LANDSCAPE AND VISUAL REVIEW
OF THE DEVELOPMENT CONSENT ORDER (DCO) APPLICATION
FOR THE SPRINGWELL SOLAR PROJECT
FOR
LINCOLNSHIRE COUNTY COUNCIL
&
NORTH KESTIVEN DISTRICT COUNCIL

May 2025

Landscape and Visual Review

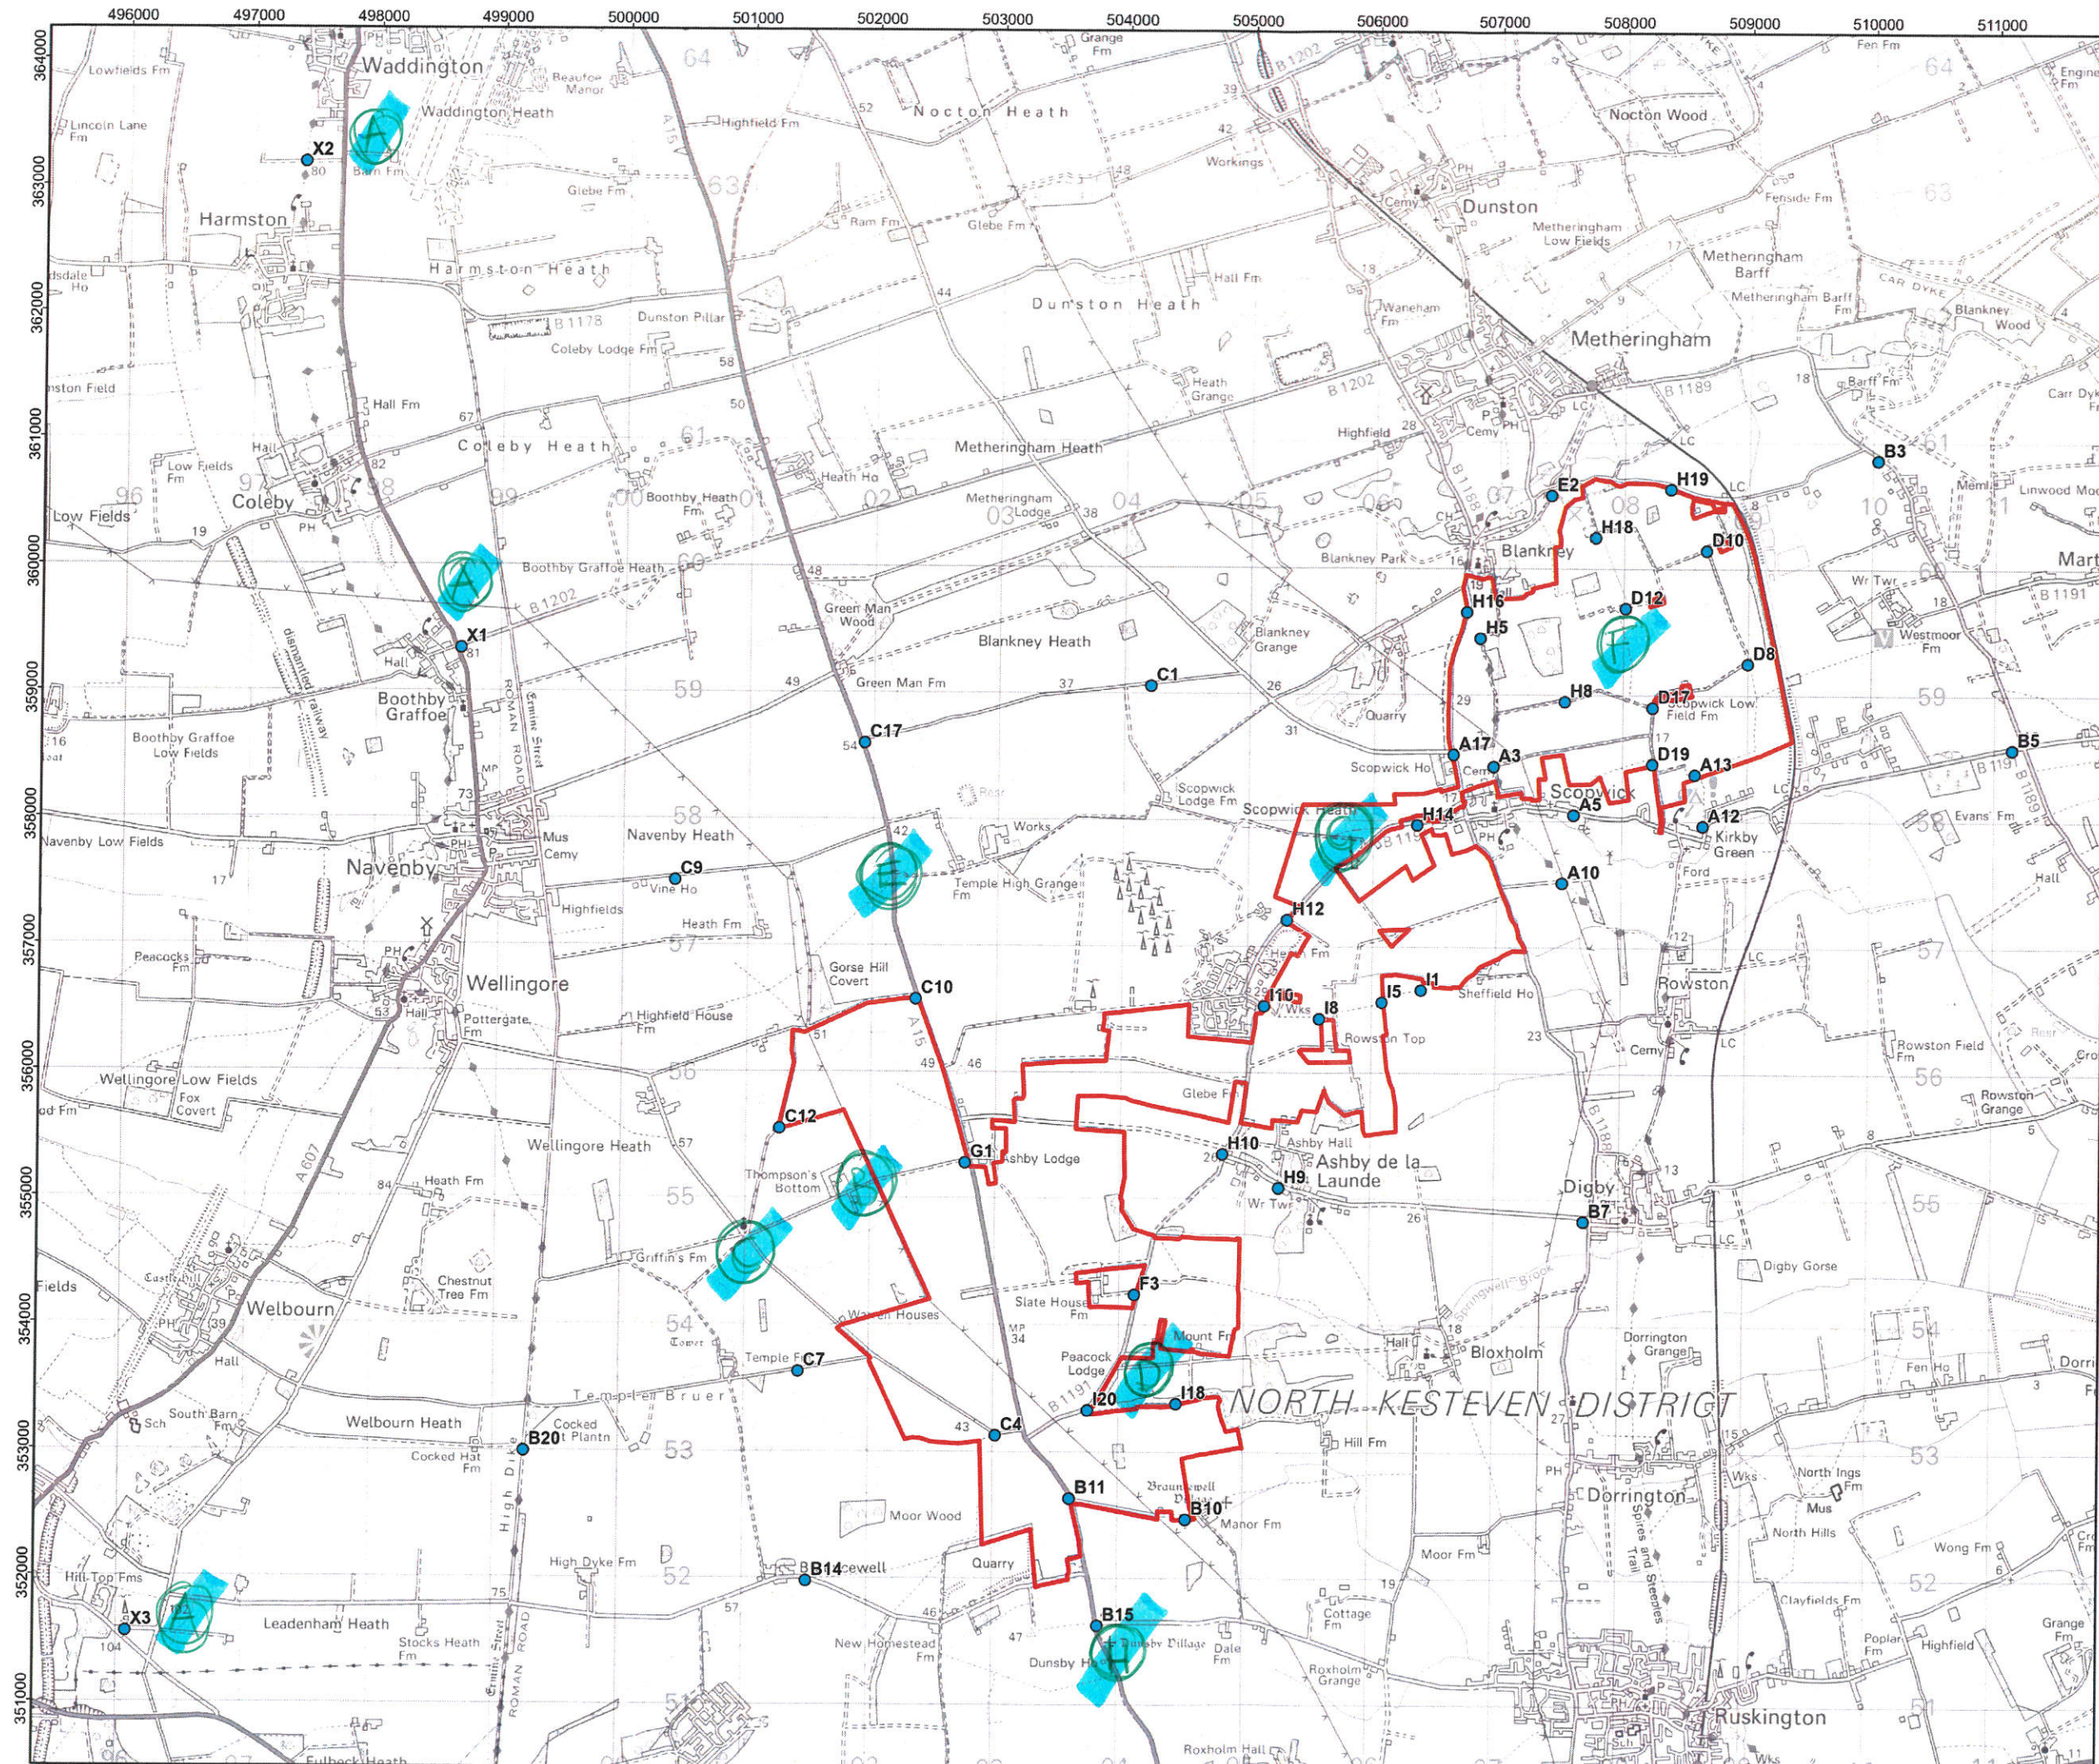
The following additional comments are in regards to visibility of the site from general groups of receptors and viewpoints, and we have also marked up the plan provided to us by Stephenson Halliday, appended to this memo, which locates the comments below. We would suggest the comments provided are discussed further prior to finalising. If it is considered that suggested views of the site and development are not attainable from any identified areas, or viewpoints not appropriate, a statement to this effect should be provided to aid transparency. It is important that all viewpoint photography should provide the most advantageous views of the site and proposed development, and avoid any obstructions to a clear view such as cars:

- A. **Longer distance views identified (X2, X1, X3) are unlikely to provide views of the Development, and at this stage views from receptors in these areas to the west, such as communities at Waddington, Navenby, Wellingore or Welbourn or along the A607, or PROW in these areas. However, a view from more sensitive receptors in these areas would be useful to demonstrate this, such as along the eastern settlement edge.**

- B. **Potential additional viewpoint included from the area around Thompson's Bottom and western boundary.** This would provide a clear view east to the site adjacent to the OH line and will include views of the A15 and also longer range views to the east;

- D. **Please review visibility and potential views of the site and development from within Bloxham Wood Nature Reserve.** Subject to the location of the substation, it is unlikely that this would require an additional viewpoint, as we have assumed Viewpoints I20 and I18 would provide an illustrative view of this), however views from this location should be considered within the assessment as it is unclear as to the extent as to which vegetation would screen views of the development from this location as a path runs close to the southern edge of the woods;

- G. While views along the B1191 between Scopwick and RAF Digby are covered by Viewpoints H12 and H14, would a view **covering Scopwick Mill and PROW Scop/13/1** be required to cover more sensitive receptors in this area? Alternatively, these views may be covered by the assessment when discussing potential receptors, however it is important to identify these.
- H. Viewpoint B15 provides a clear view north to the Site from users of the A15. The heritage asset of Dunsby Village lies just to the south. Is there a way to capture this in the view without compromising the clear view to the Site, or would B15 be representative of this potential view?
